Access Compliance Report

Public Rights-of-Way

(Curb Ramps)

Intersection ID: 19683	Main Street: CONGRESS_ST	Cross Street: CARNEGIE_BV	Location: SE
ADA ID: BFD1F079A32B	Ramp Type: PerpDiag	Initial Pass/Fail: Fail	Overall Compliance: No
Severity Score: 12.5			
Codes/Mitigation Info/Possible Solution		Field Measurements/Component Compliance

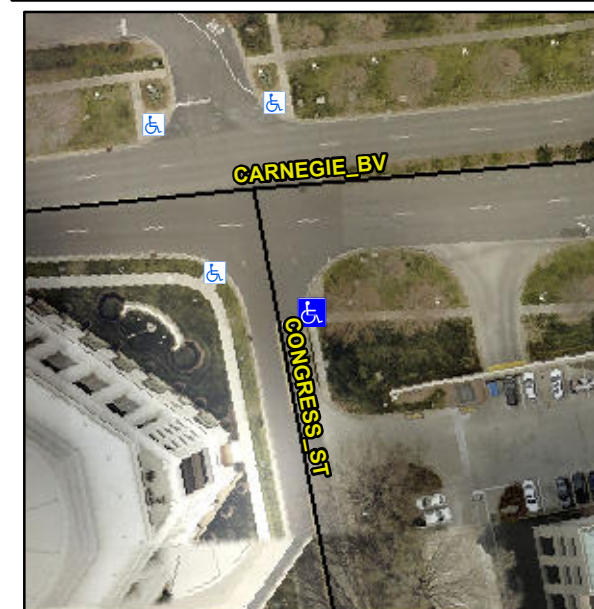
R304.5.3

Compliance	Description	Data	Compliance	Description	Data
N/A	Ramp Length (in)	102.0	Yes	Ramp Slope (%)	6.1
Yes	Ramp Width (in)	48.0	No	Ramp XSlope (%)	5.3
N/A	Flare Type LT	N/A	N/A	Flare Type RT	N/A
N/A	Flare Slope LT (%)	N/A	N/A	Flare Slope RT (%)	N/A
N/A	Flare Traversable LT?	N/A	N/A	Flare Traversable RT?	N/A
N/A	Landing Length (in)	N/A	N/A	DWS Provided?	N/A
N/A	Landing Width (in)	N/A	N/A	DWS Contrast?	N/A
N/A	Landing Slope (%)	N/A	N/A	DWS Length (in)	N/A
N/A	Landing X Slope (%)	N/A	N/A	DWS Full Width?	N/A
N/A	Landing Curb? (Y/N)	N/A	N/A	DWS Offset (in)	N/A
N/A	Shared Landing?	N/A			
N/A	Gutter Ponding?	N/A	N/A	Gutter Slope (%)	N/A
N/A	Gutter Lip Ht (in)	N/A	N/A	Gutter X Slope (%)	N/A
N/A	Painted X Walk1?	No	N/A	Painted X Walk2?	No
	X Walk 1 Direction	To N		X Walk 2 Direction	To NW
N/A	X Walk 1 Width (in)	N/A	N/A	X Walk 2 Width (in)	N/A
	X Walk 1 Slope (%)	3.5		X Walk 2 Slope (%)	2.4
	X Walk 1 X Slope (%)	3.9		X Walk 2 X Slope (%)	5.3

Remove & Replace Curb Ramp With Two New Directional Ramps or Equivalent.
